Project Name:	Open Source OpenFrame Draft.dft
Name of Part:	OF-IN-MCH

Sheet 8 OF 27

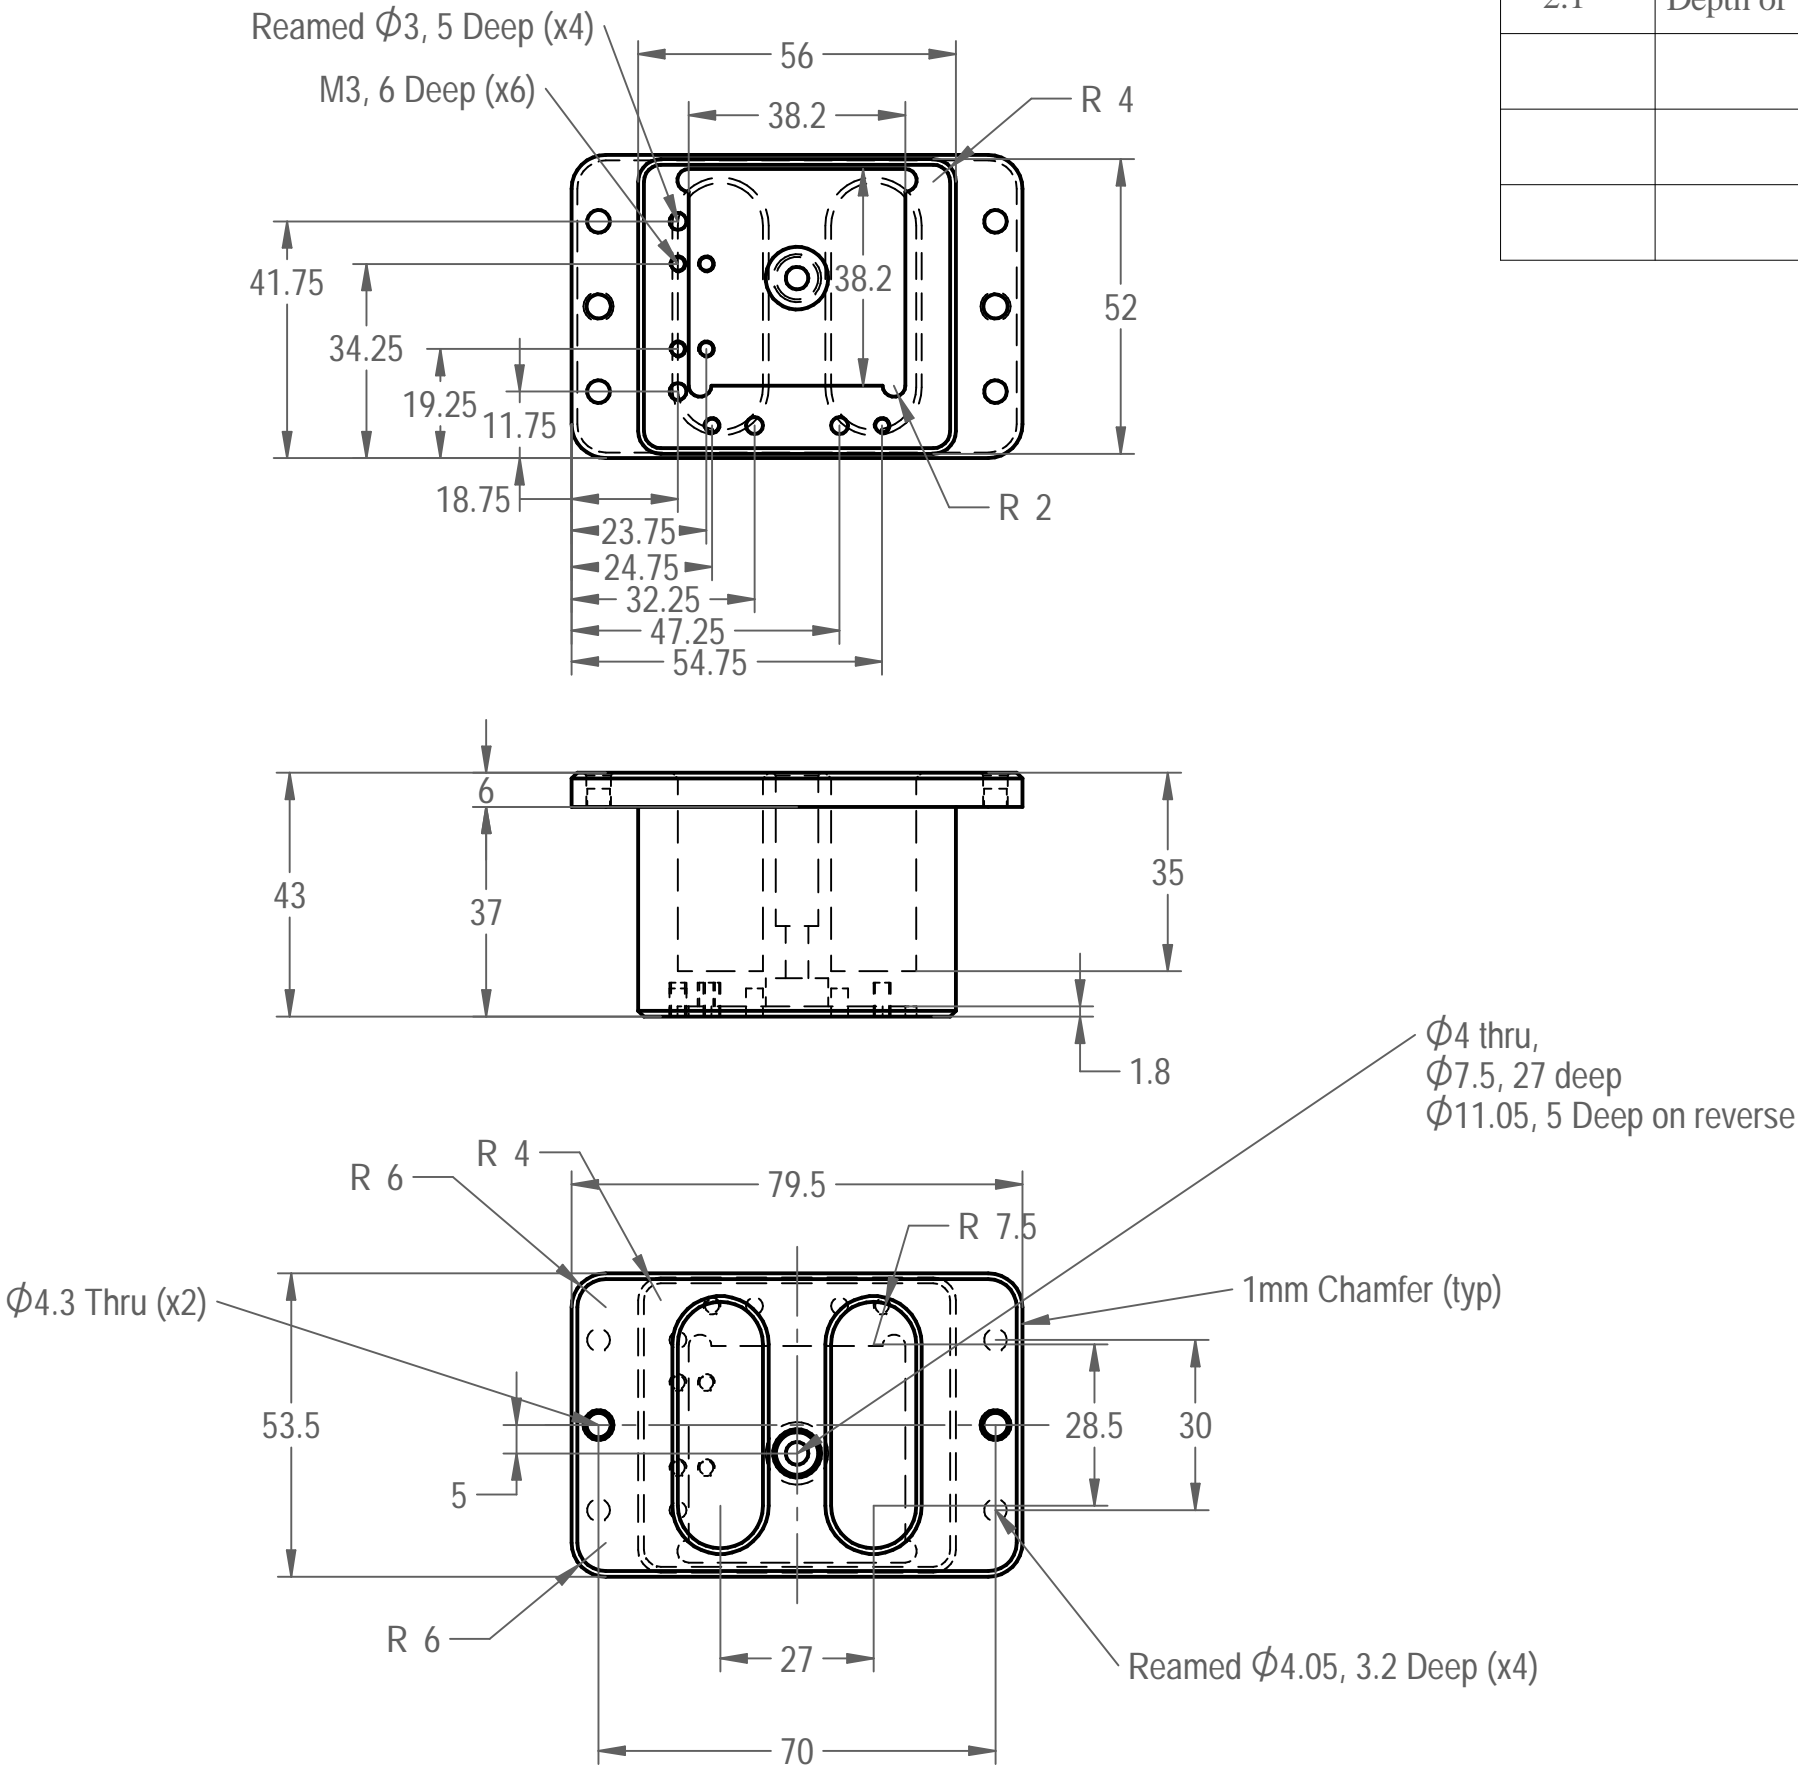
Rev. No.	Changes Made
2.1	Depth of 7.5mm Counterbore changed to 27mm deep
